September 30, 2011

**Re: RockTenn / Franklin County  
fka, Smurfit-Stone Recycling Company  
Industrial Storm Water Permit 4GR00467\*DG**

This letter is written in regard to the storm water inspection that I conducted at RockTenn located at 1015 Marion Road in Columbus, Ohio. The inspection was conducted on September 20, 2011, to insure compliance with your industrial storm water general permit. The following items were noted during the inspection, also please see attached pictures:

RockTenn  
Oil discharge to storm water drain  
Scioto River Watershed  
September 20, 2011  
Photo by: Greg Sanders

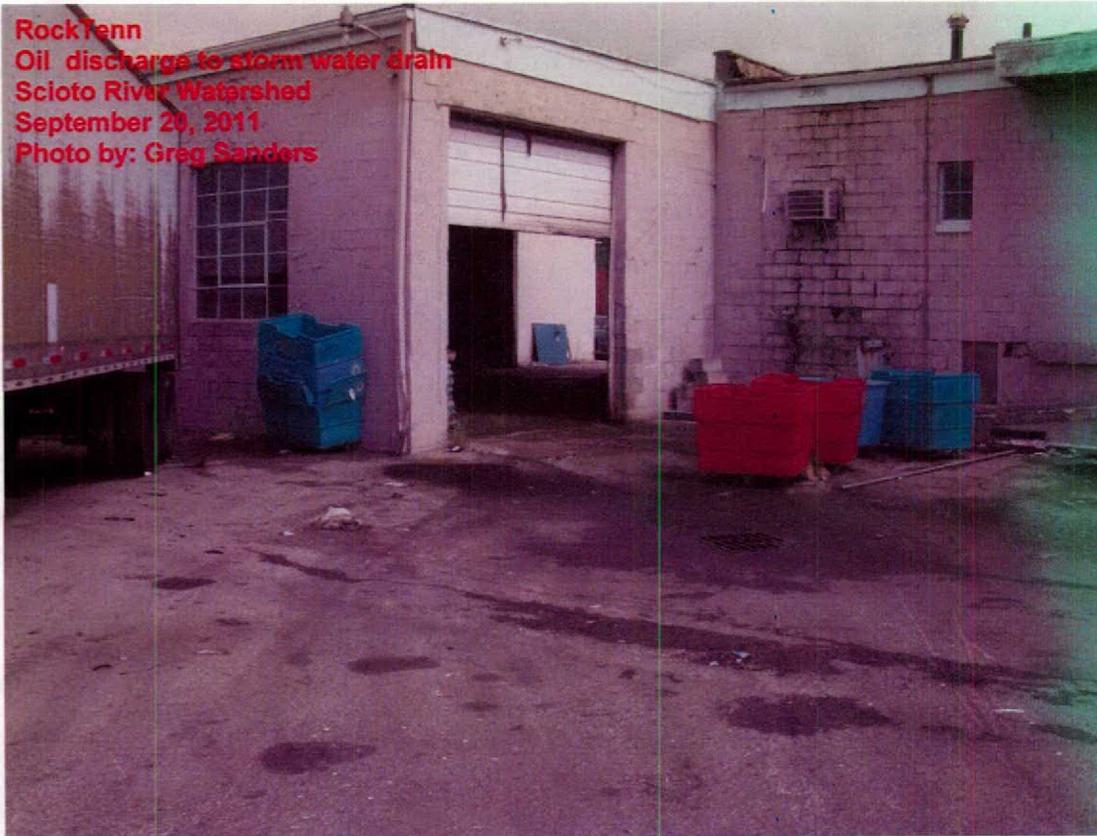
1. Activities in the maintenance shop were discharging oil and grease to a storm water drain. New controls and best management practices need to be put in place to prevent the discharge of oil and grease to the storm water drain.

RockTenn  
Oil stains on pavement  
No spill kits  
Scioto River Watershed  
September 20, 2011  
Photo by: Greg Sanders

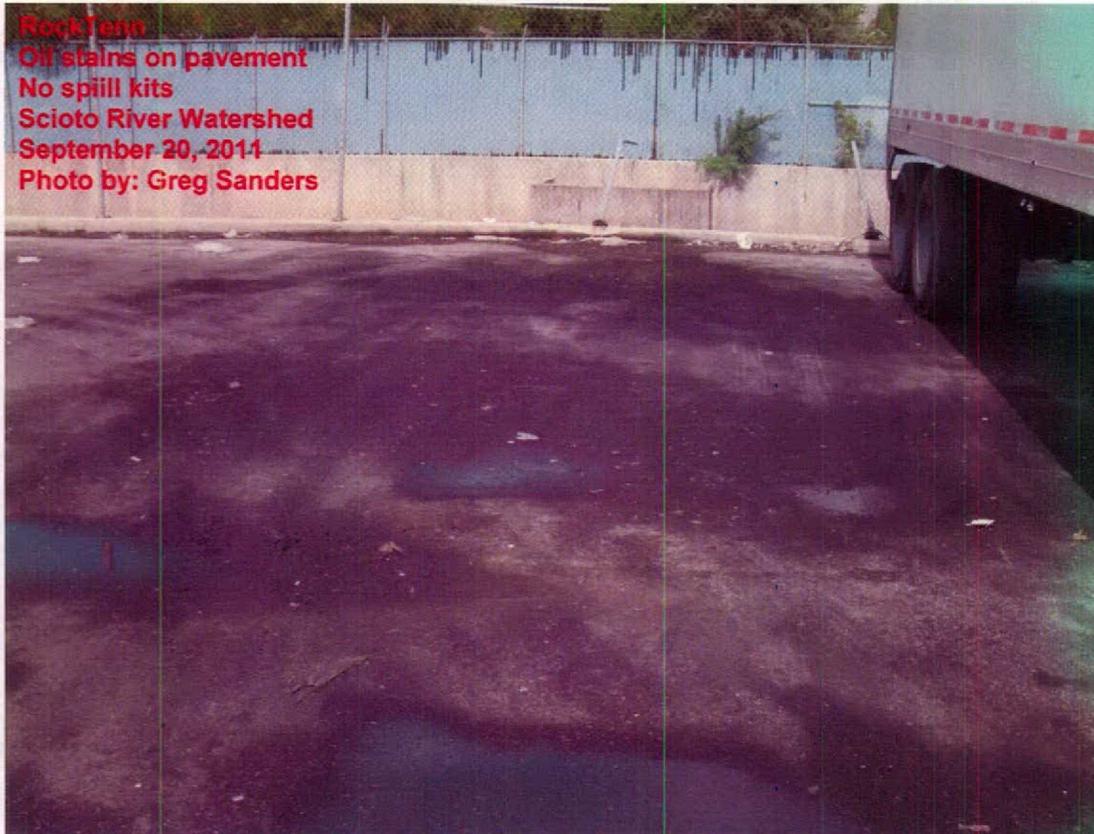
3. There were numerous oil and grease stains on the pavement through-out your facility. There needs to be better housekeeping at the site in order to prevent and absorb spills. Spill kits should be located through-out the facility at loading/unloading areas and transfer stations.
